## Public Facilities Committee Report

**#305-20      Request for a main drain extension at 21 Verndale Road**

Memorandum

To: Councilor Alison Leary, Facilities Committee Chair.  
From: John Daghlian, Associate City Engineer  
Re: Drain Main Extension Request 21 Verndale Road  
Date: July 8, 2020  
CC: Jim McGonagle, Commissioner  
Shawna Sullivan, Chief of Staff  
Lou Taverna, PE City Engineer  
Ted Jerdee, Director of Utilities  
Doug Valovcin, Deputy Director  
Cassidy Flynn, Committee Clerk

**PROPOSED SITE PLAN DRAINAGE PROFILE**  
 21 VERNDALE ROAD  
 NEWTON, MASSACHUSETTS 02461  
**RAY & ASSOC., Inc.**  
 21 HIGHLAND AVENUE  
 NEEDHAM, MASSACHUSETTS 02451  
 TELEPHONE: (781) 443-8200

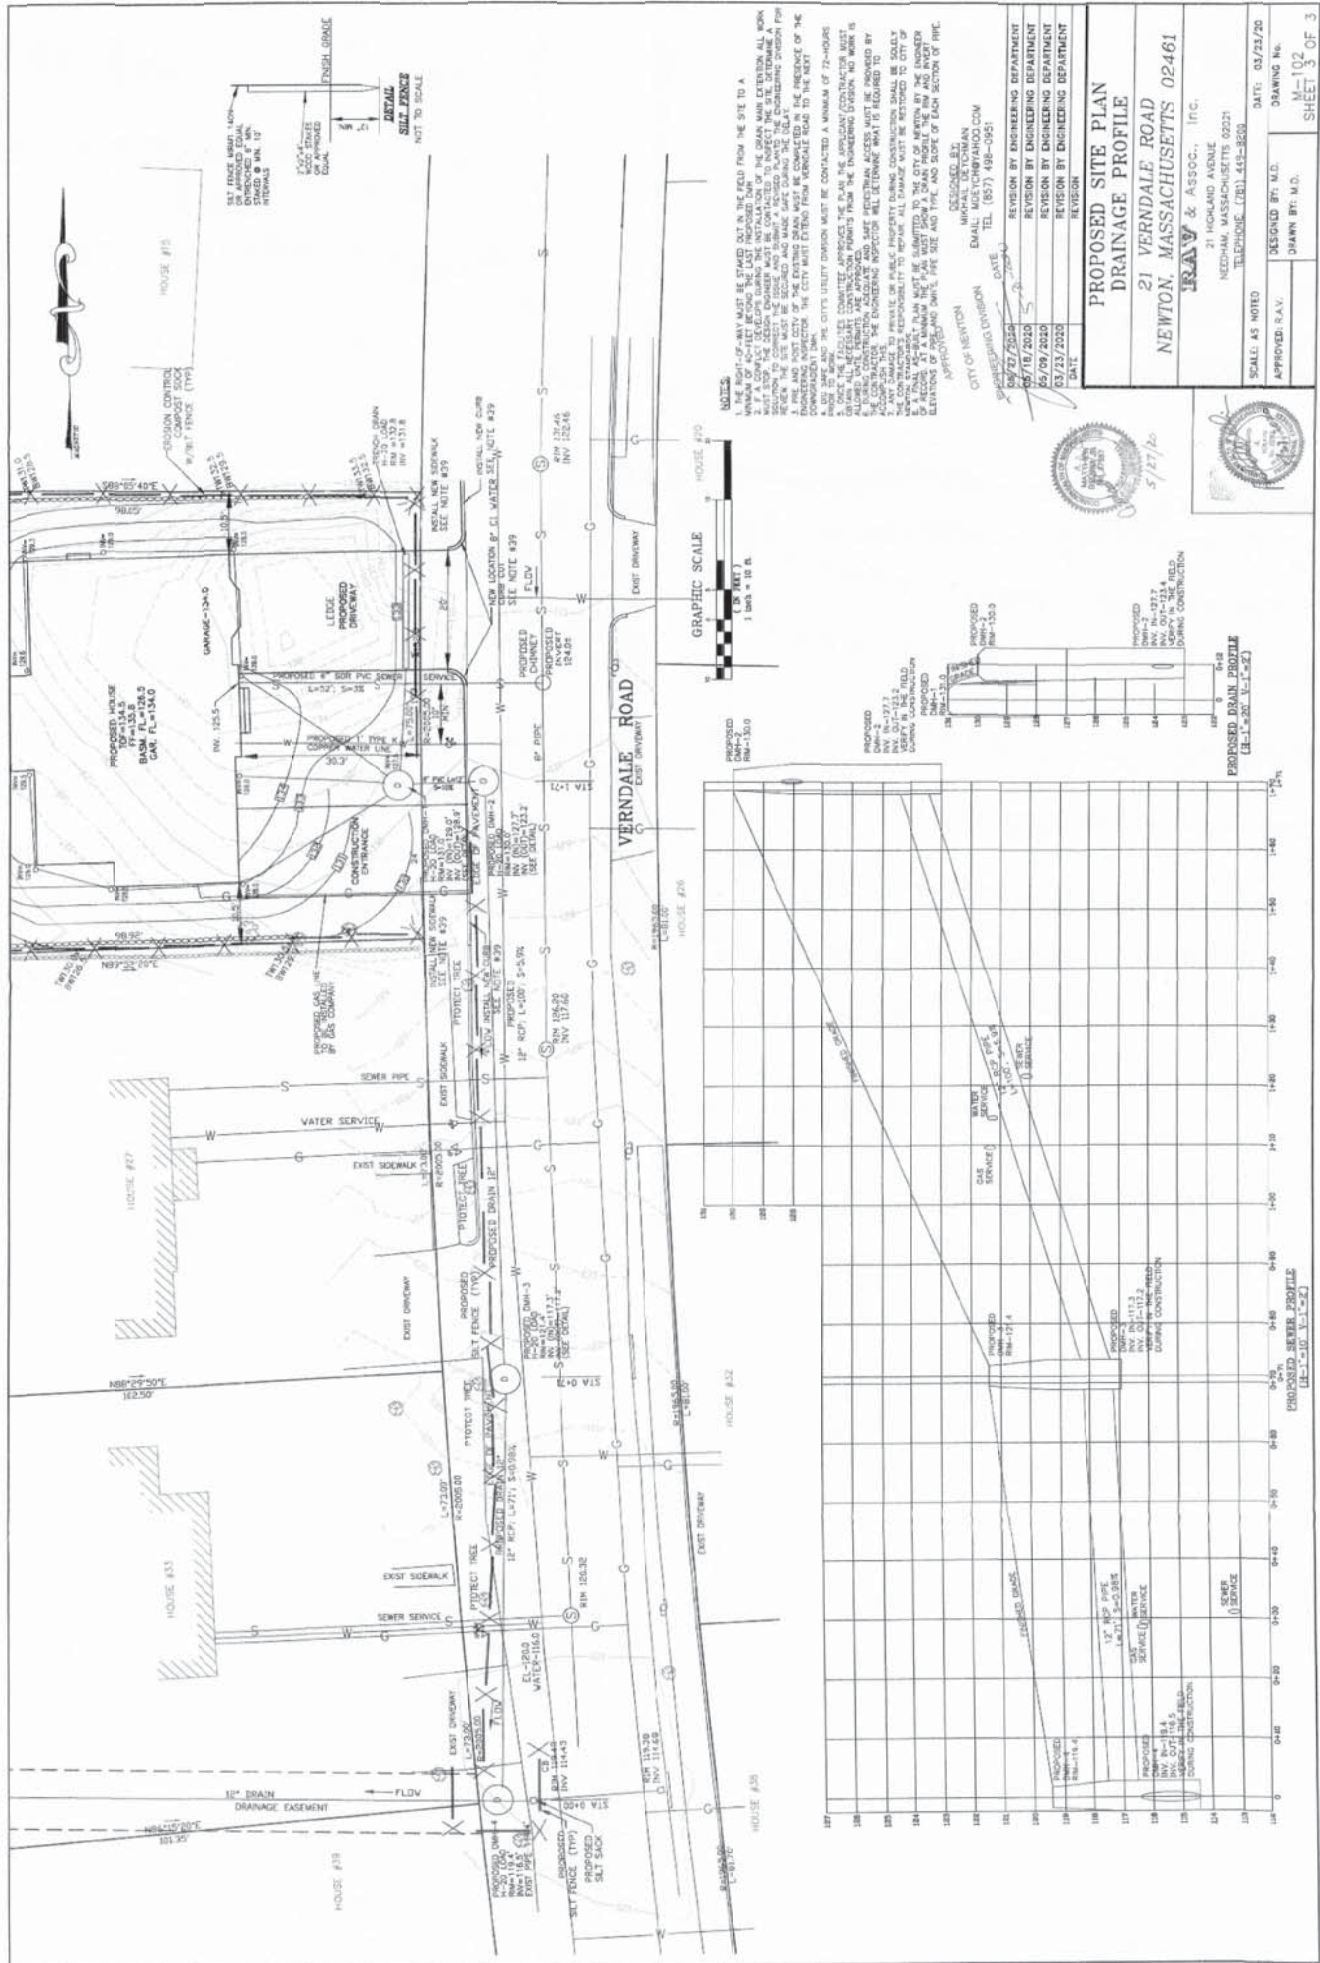
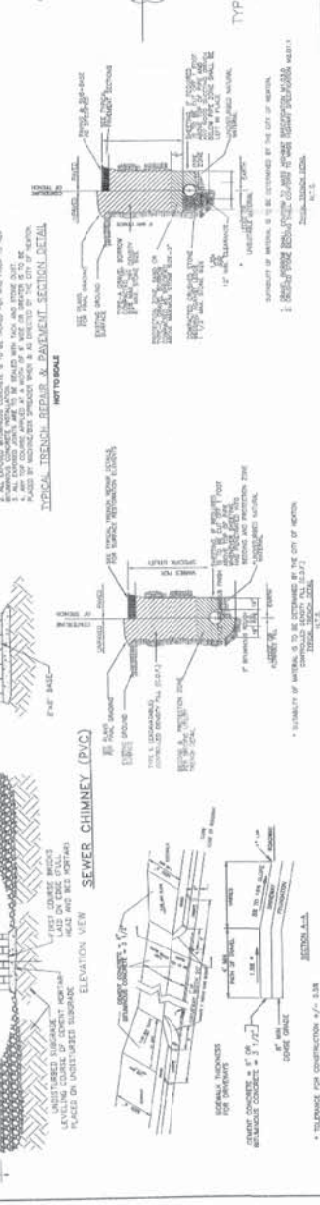
This drain main extension is being requested by the applicant who is paying 100% of the installation cost. The need for the drain main extension is precipitated from the fact that the building site has ledge and very limited on-site infiltration capability; therefore, an overflow connection is needed. It has been the policy of the DPW that applicants install an on-site drainage system to infiltrate to the maximum extent practicable and if necessary an over flow connection is allowed to the City's drainage system; in this case the closest system is 170 feet

downstream. The design entails installing approximately 170-feet of 12" diameter reinforced concrete pipe along the westerly gutter line of Verndale Road. The proposed drainpipe will have 3 new drain manholes installed to address grade changes and flow direction. Prior to any construction the engineer of record shall stake out the limits of the right of way to ensure that there is no encroachment of drainpipe on private property.

Based on a site visit today my only concern is that there are a couple of mature street trees along the proposed alignment that may have roots under the roadway (see photo above). To minimize impact to the tree roots I am proposing the following two Council conditions:

1. Substitute 12" ductile iron pipe for the 12" reinforced concrete pipe. This pipe has a smaller overall pipe diameter than reinforced concrete which would require a narrower trench.
2. The contractor shall contact the City's Tree Arborist prior to excavation to have him assess the trees and any impact that the alignment may have on the root system.
